World Forum for Harmonization of Vehicle Regulations
Working Party on General Safety Provisions
104th session

Regulation No. 110 (Specific equipment for CNG)
**Proposal for amendments to Regulation No. 110
 (Specific equipment for CNG and/or LNG)**

**Submitted by the Chair of the Task Force on Liquefied Natural Gas
 vehicles***

Figure 1-1
Flow scheme for CNG **and/or LNG** components classification

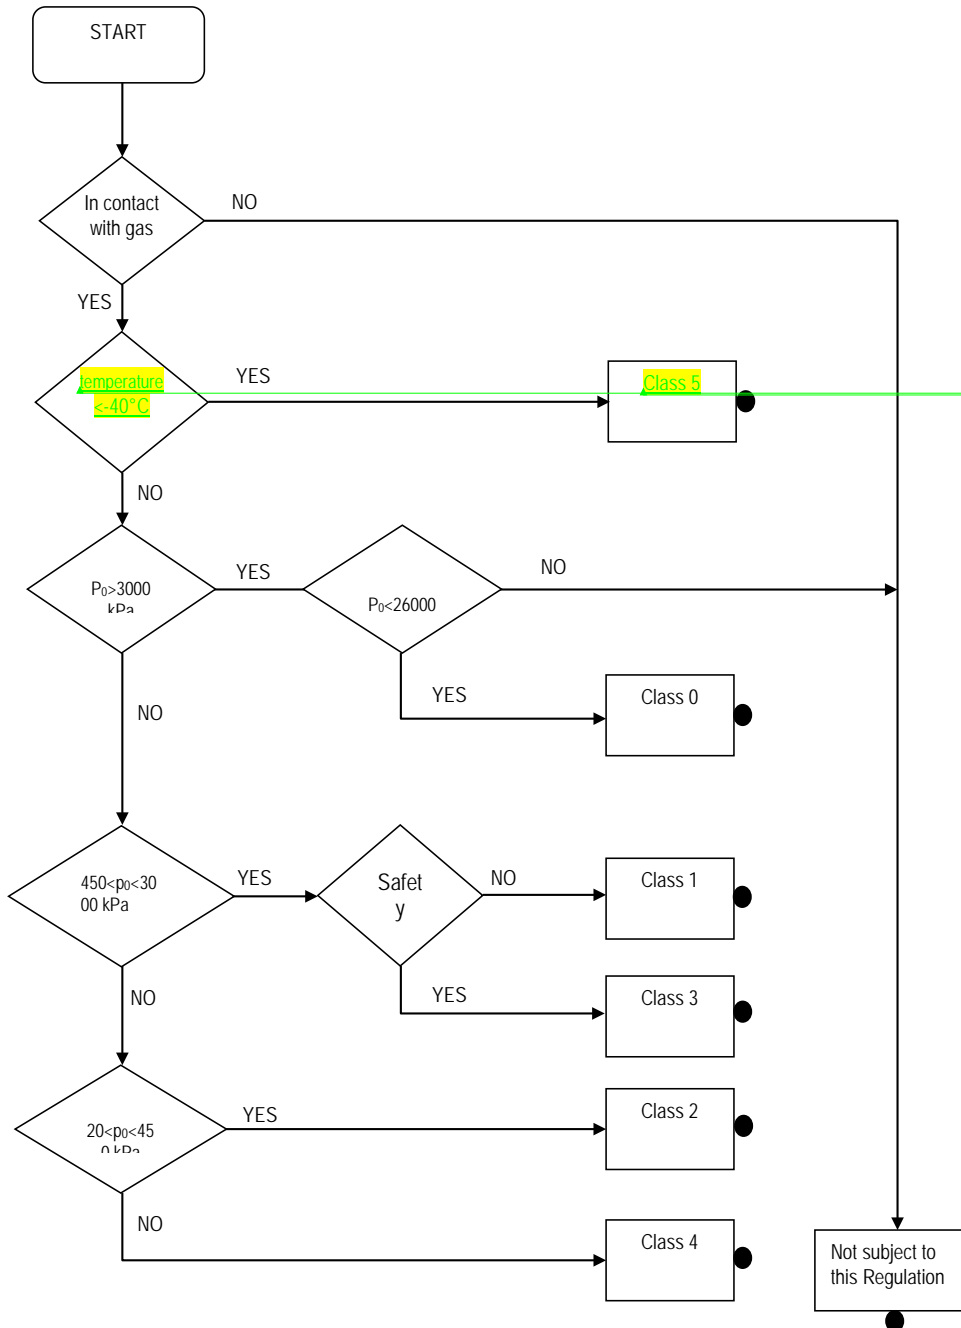
Comment [DP8]: Table is updated with the new class 5 for LNG use.

Figure 1
20 MPa filling unit (receptacle) for M₁ and N₁ vehicles

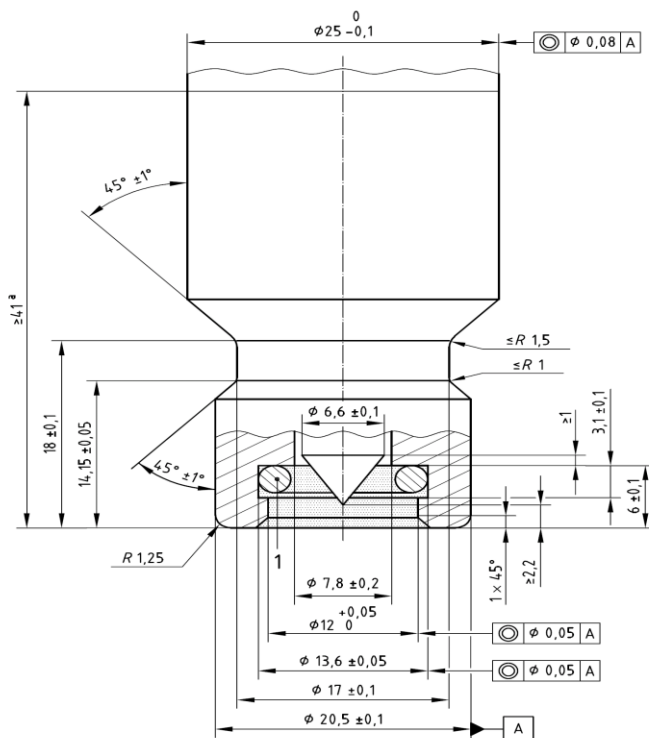
Comment [A57]: After checking with Paul, we don't know why this is not included in the last official version sent by Romain, so we decided to include it here. We should confirm with Romain if it was deleted on purpose or not

of this regulation. In this case, dimension 25 +0/-1 becomes 24 +0/-1 in Figure 1 and 35 +0/-1 becomes 34+0/-1 in Figure 2.
